## **NOTICE OF PUBLIC HEARING**

### **Minor Variance**

**APPLICATION NO.:** HM/A-21:111

**SUBJECT PROPERTY:** Municipal address **472 Dundurn St. S., Hamilton**

**1 SITE PLAN**  
 1" = 10'-0"

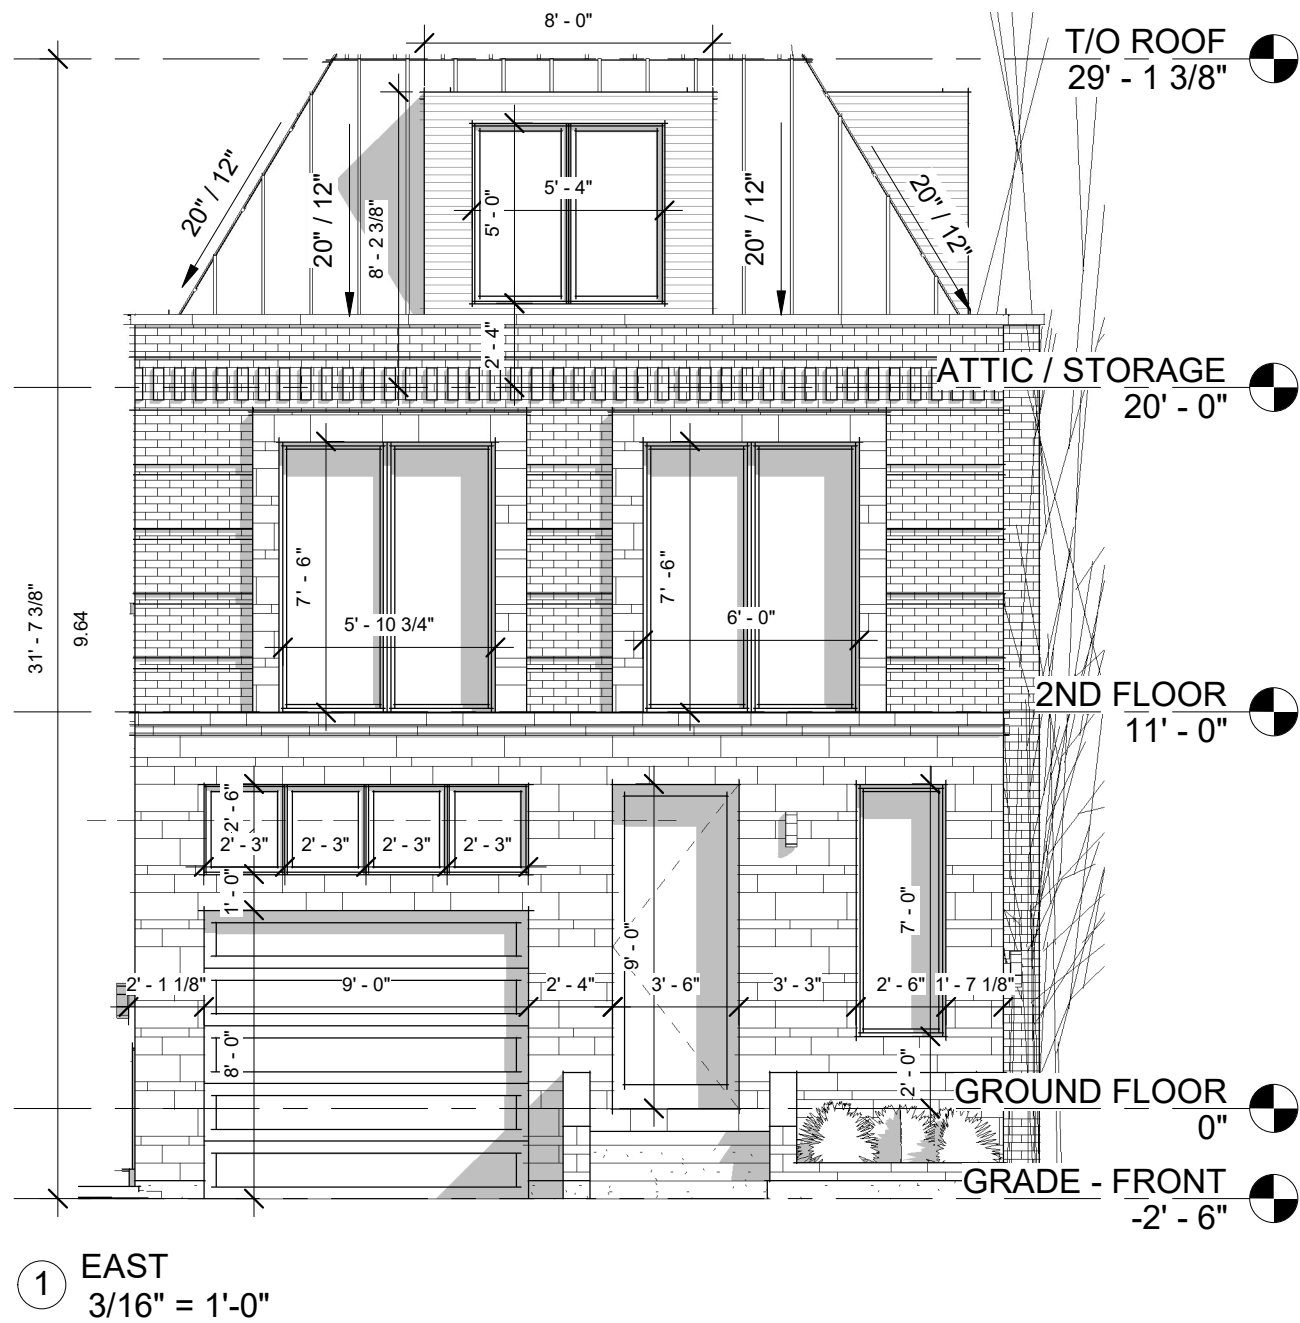
5. It is noted that a minimum of 51.3% of the gross area of the front yard is provided as landscaped area. A further variance may be required if the area of the front yard provided as landscaped area has not been calculated in accordance with Section 18(14) and 18A(14d) of the Zoning By-law.
